PIC18F6620/8620/6720/8720

PIC18F6620/8620/6720/8720 Rev. A3 Silicon/Data Sheet Errata

The PIC18F6620/8620/6720/8720 parts you have received conform functionally to the Device Data Sheet (DS39609B), except for the anomalies described below.

FIGURE 26-3: PIC18F6620/6720/8620/8720 VOLTAGE-FREQUENCY GRAPH (INDUSTRIAL, EXTENDED)

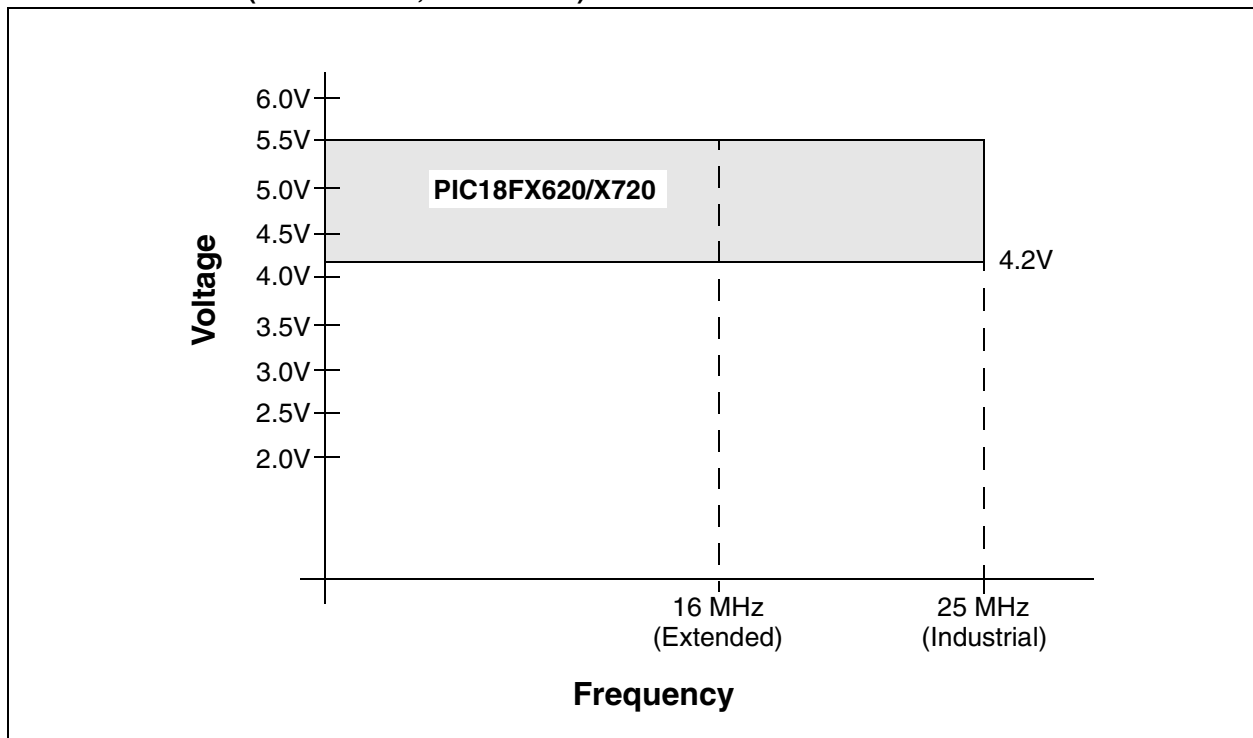
1. Module: Voltage-Frequency Graph

In Section 26.0 “Electrical Characteristics”, the following figure has been updated to clarify the voltage frequency for extended devices.

FIGURE 11-1: TIMER0 BLOCK DIAGRAM IN 8-BIT MODE

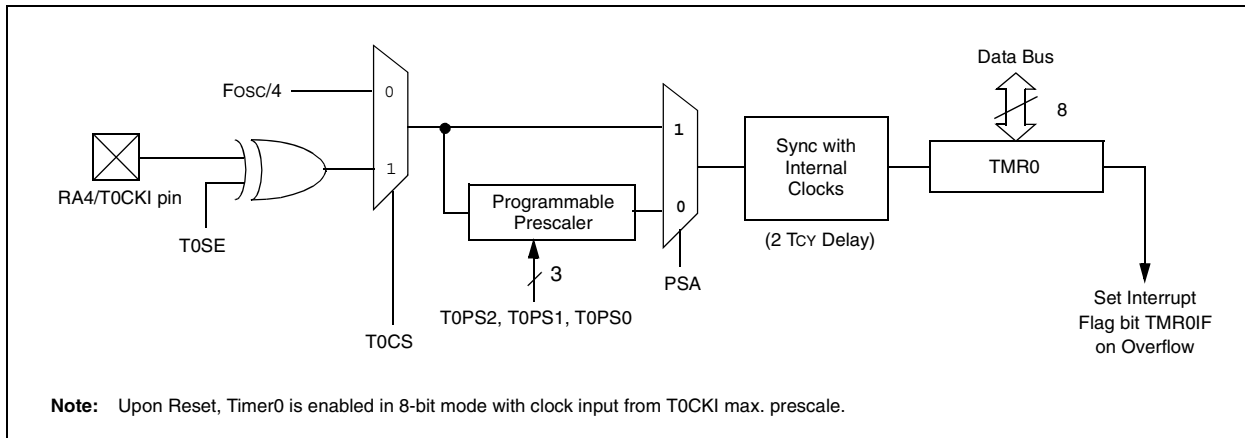
10. Module: Timer0 Block Diagram in 8-Bit and 16-Bit Modes

The PSA multiplexor bit values in Figures 11-1 and 11-2 do not match the text description of the Timer0 PSA bit in the T0CON register.

The bit values have been corrected by swapping the values as shown below (correct values are shown in **bold text**):
